PROJECT
Vertical Retirement Village
Lot 8002 Baringa Drive, Aura QLD

PLANS AND DOCUMENTS referred to in the PDA DEVELOPMENT APPROVAL
Approval no: DEV2024/1474
Date: 8 May 2024

8002 Retirement - Vertical Retirement Village - RFI Issue - 26/3/2024

DRAWING TITLE
STAGING PLAN

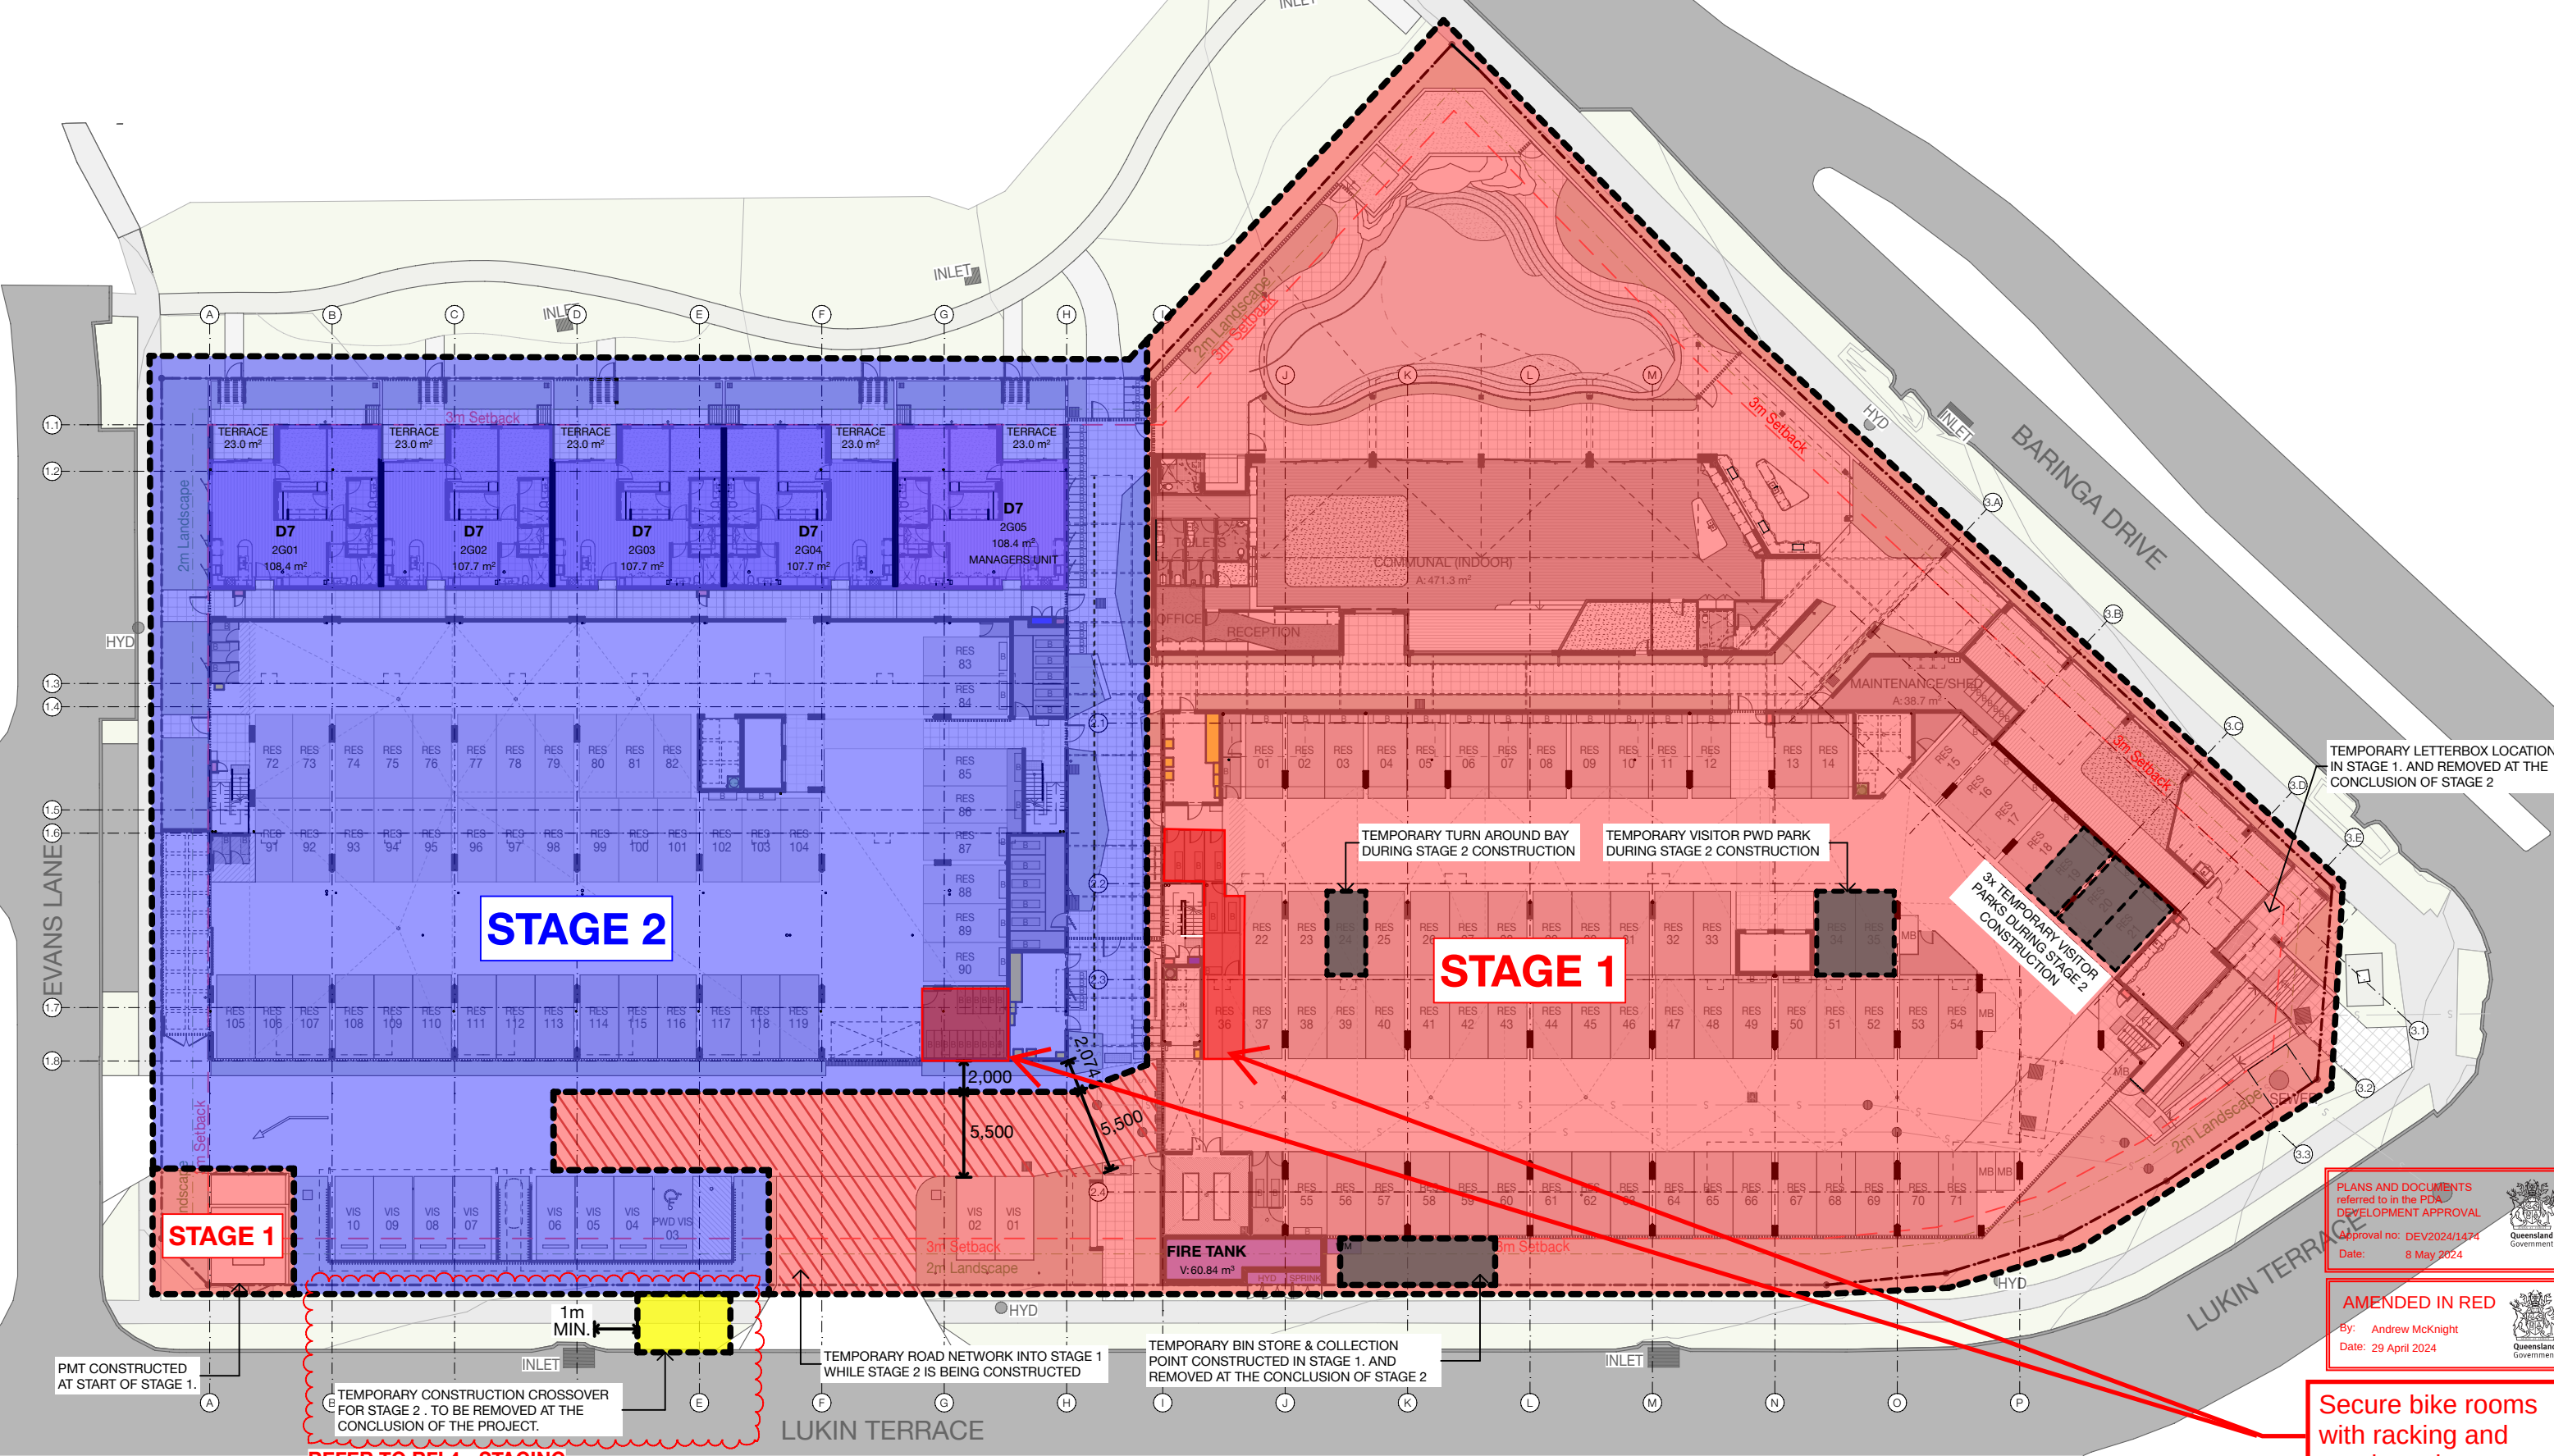
Secure bike rooms with racking and repair station

DRAWING TITLE
COMMUNAL PLAN
CLIENT
Plantation Retirement Resorts

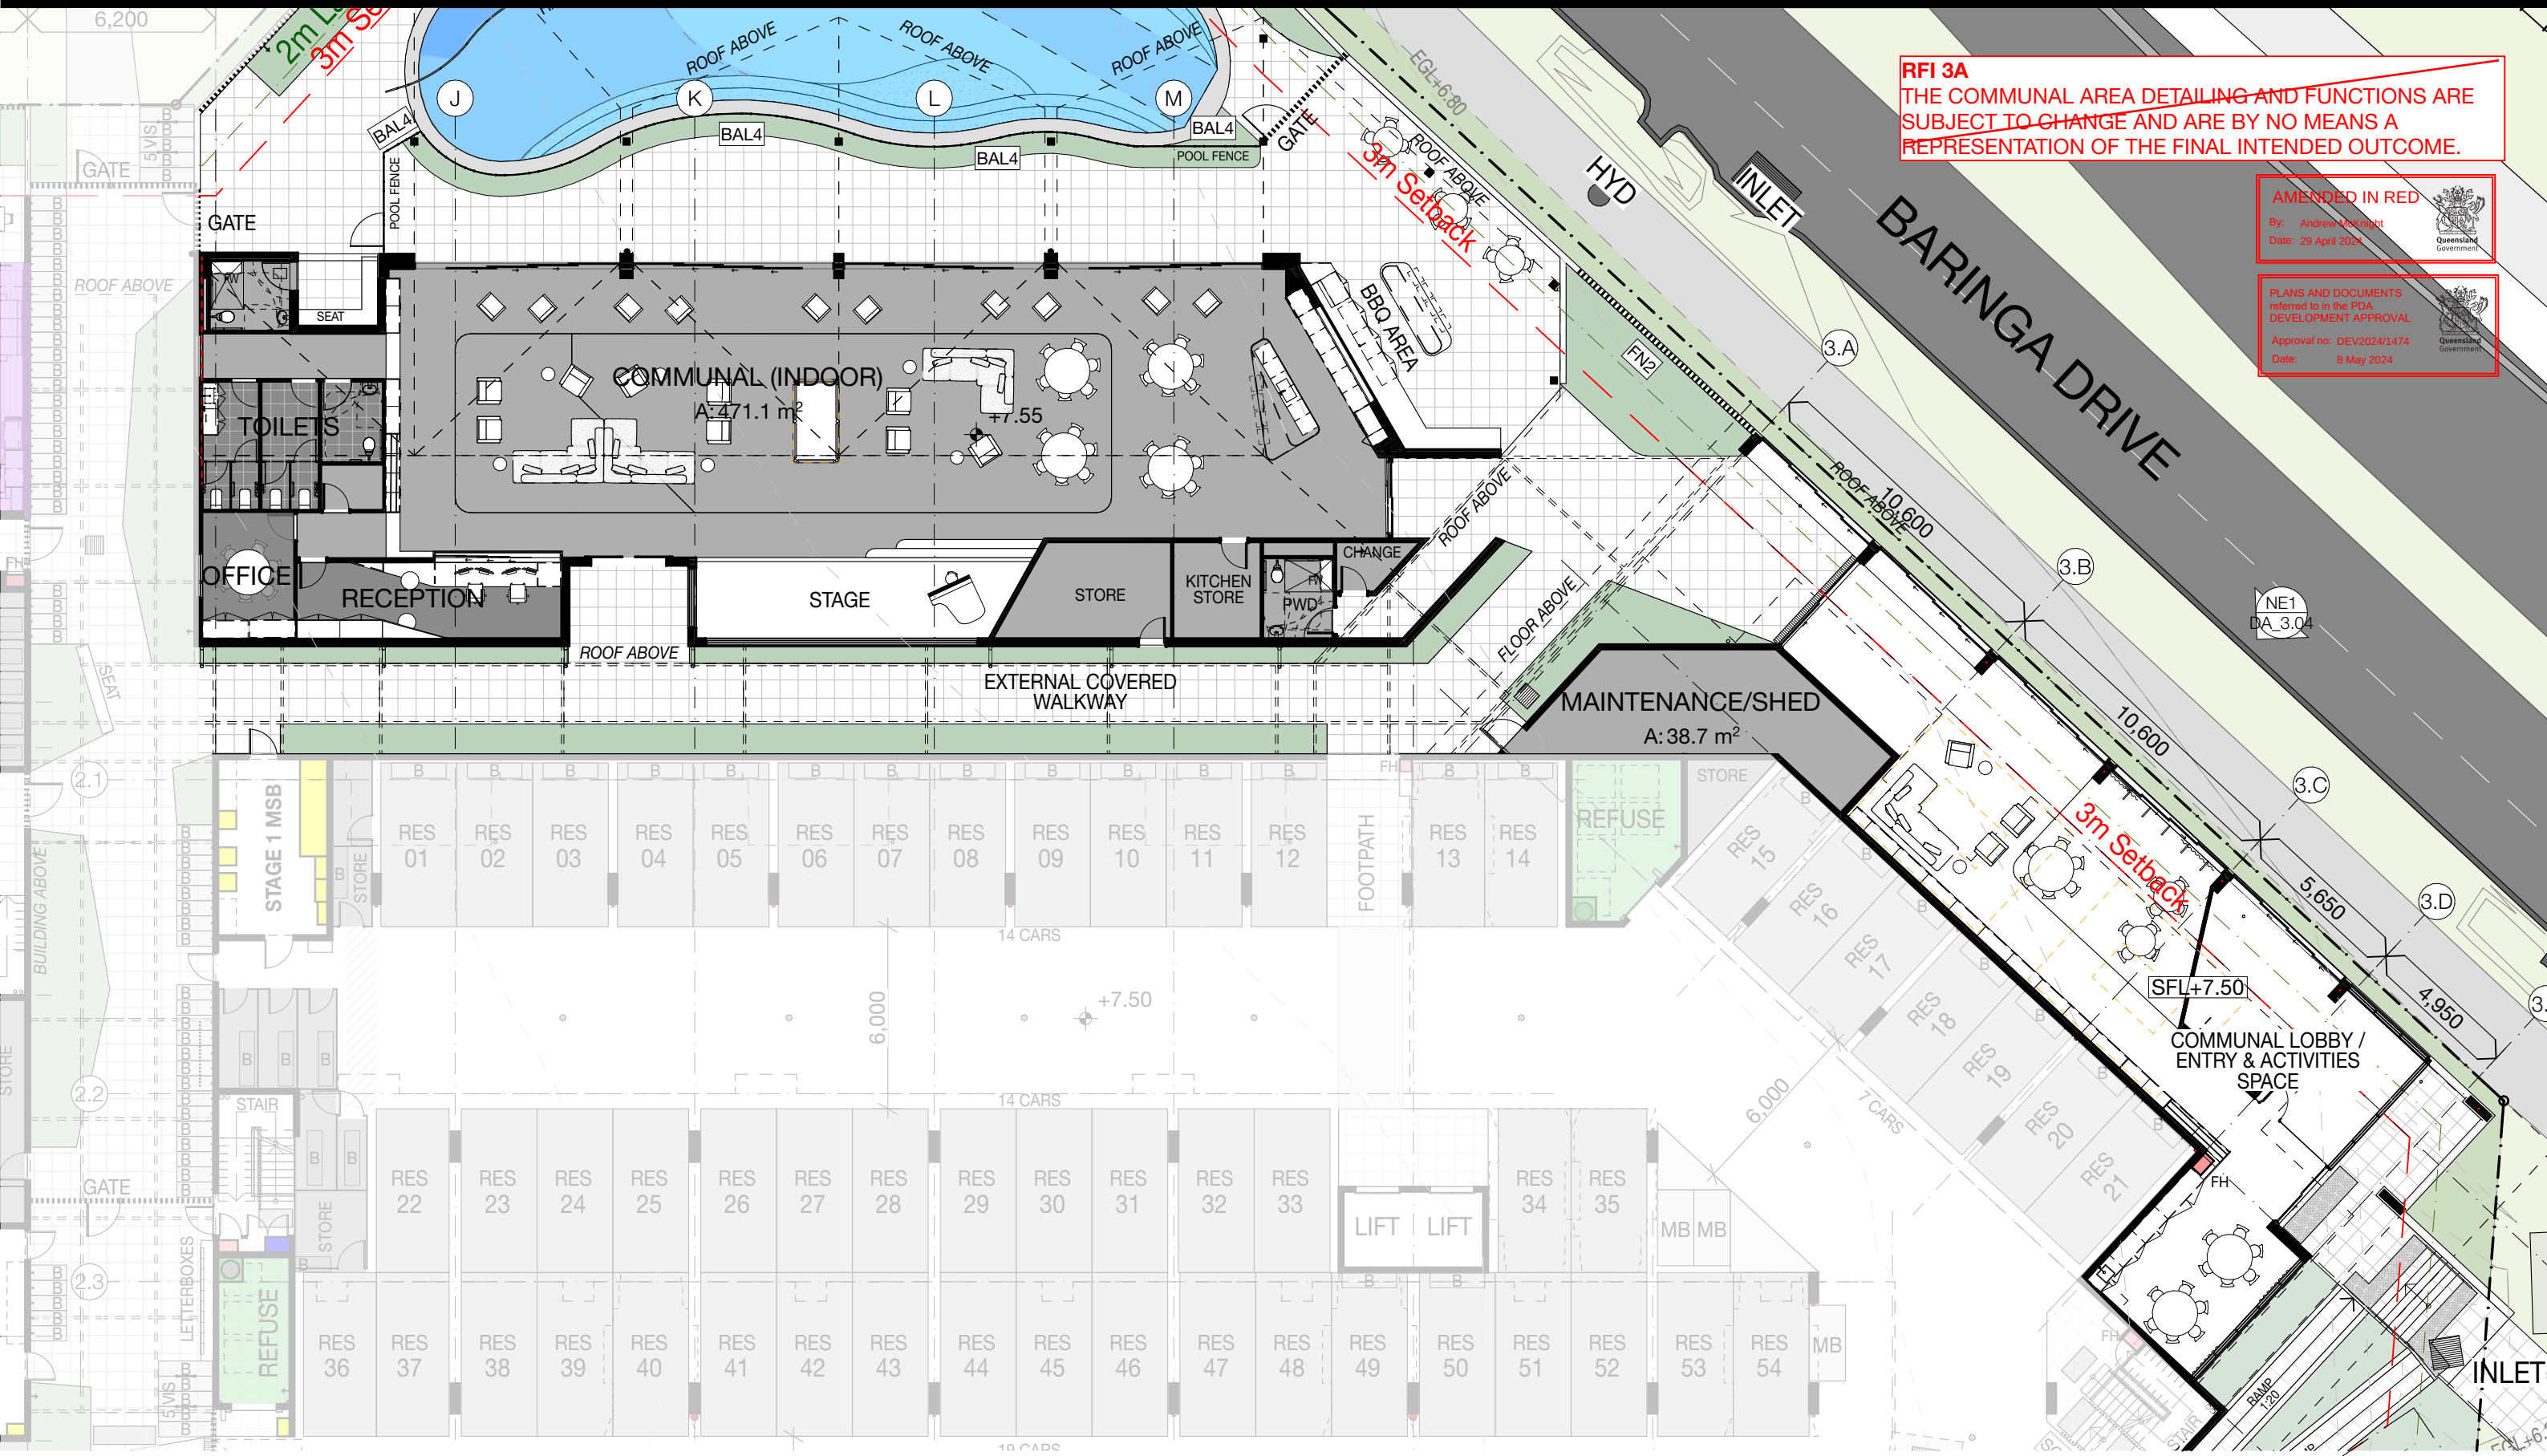
RFI 3A
THE COMMUNAL AREA DETAILING AND FUNCTIONS ARE
SUBJECT TO CHANGE AND ARE BY NO MEANS A
REPRESENTATION OF THE FINAL INTENDED OUTCOME.
